SYDNEY WESTERN CITY PLANNING PANEL ASSESSMENT REPORT

| Panel Number: | PPSSWC-113. |
| Application Number: | 2020/721/1. |
| Site Address(es): | 3-7 Digitaria Drive, Gledswood Hills. |

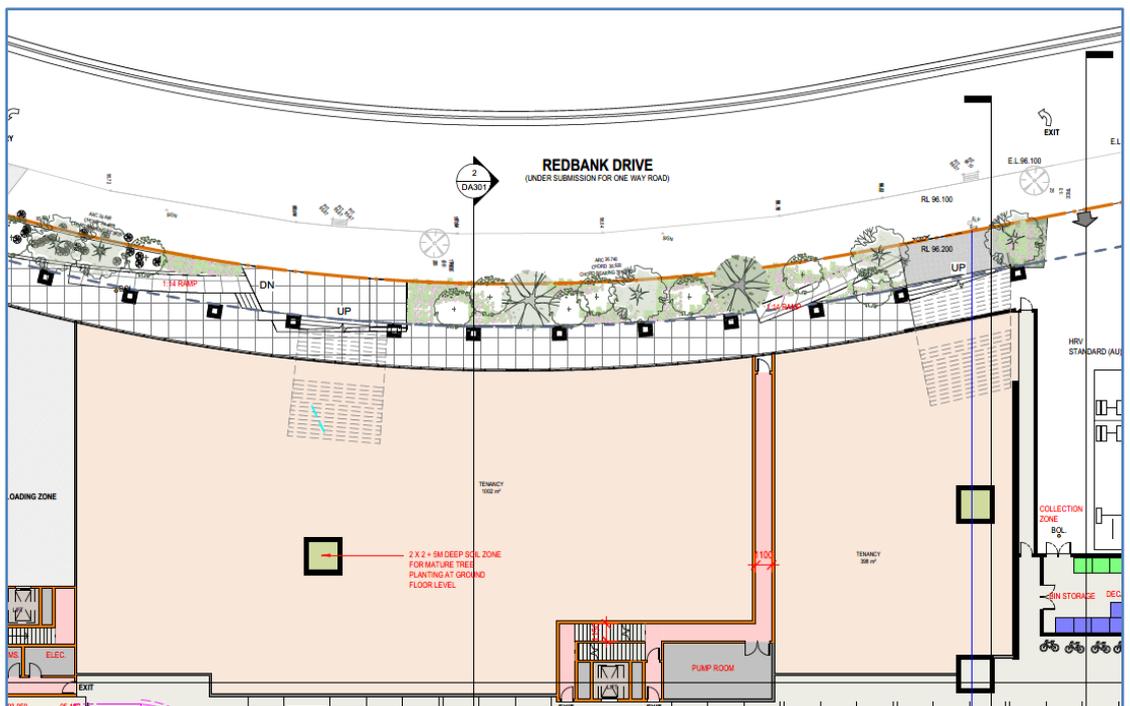
- There are steep steps leading up to the ground floor and no elevator access from Redbank Drive. Access to the ground floor from Digitaria Drive is also required via steps.
- The image below indicates how the western most building presents to Digitaria Drive. The ground floor level of that building is up to 3.5 metres above footpath level. This is a poor urban design outcome, both in terms of streetscape appearance and activation. The building also fails to provide reasonable disabled access and the vehicle entries off Digitaria Drive also detract from the appearance of this façade.

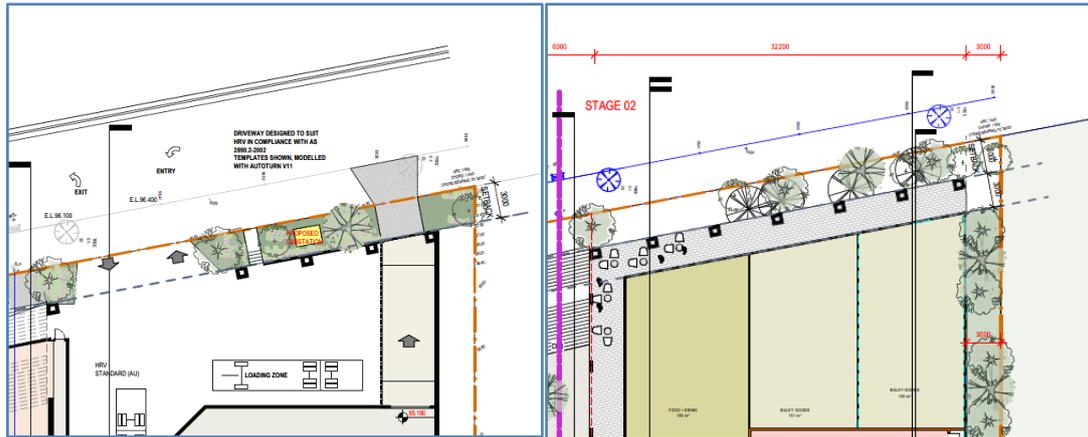
- The lower ground floor tenancies facing Redbank Drive have floor levels below footpath level (up to 1 metre). This results in poor presentation and activation of the street and compromised / less than desirable universal access (refer image below)

- The built form does not provide legible, safe and easy access for pedestrians.
- The lifts from the basement open into narrow corridors with bathroom amenities providing poor amenity for workers and visitors arriving at the complex (refer image below).

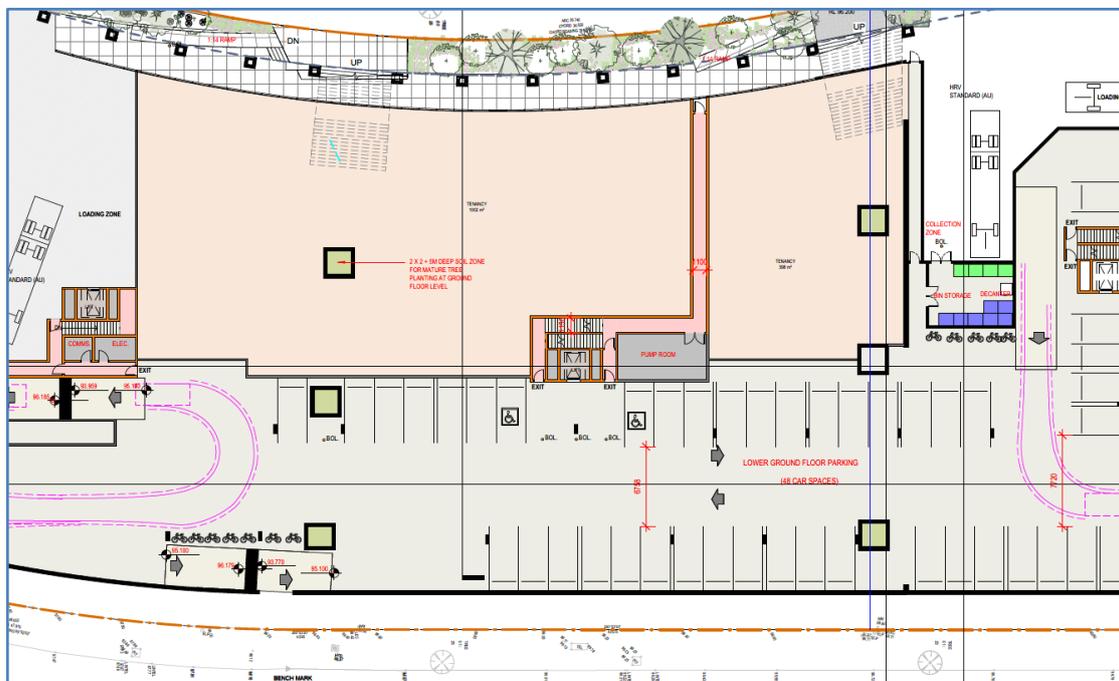
There are errors and inconsistencies in the architectural plans. For example, the lower ground floor plan indicates a driveway in the south eastern corner of the site, while this driveway is missing in the ground floor plan and replaced with landscaping (refer images below):
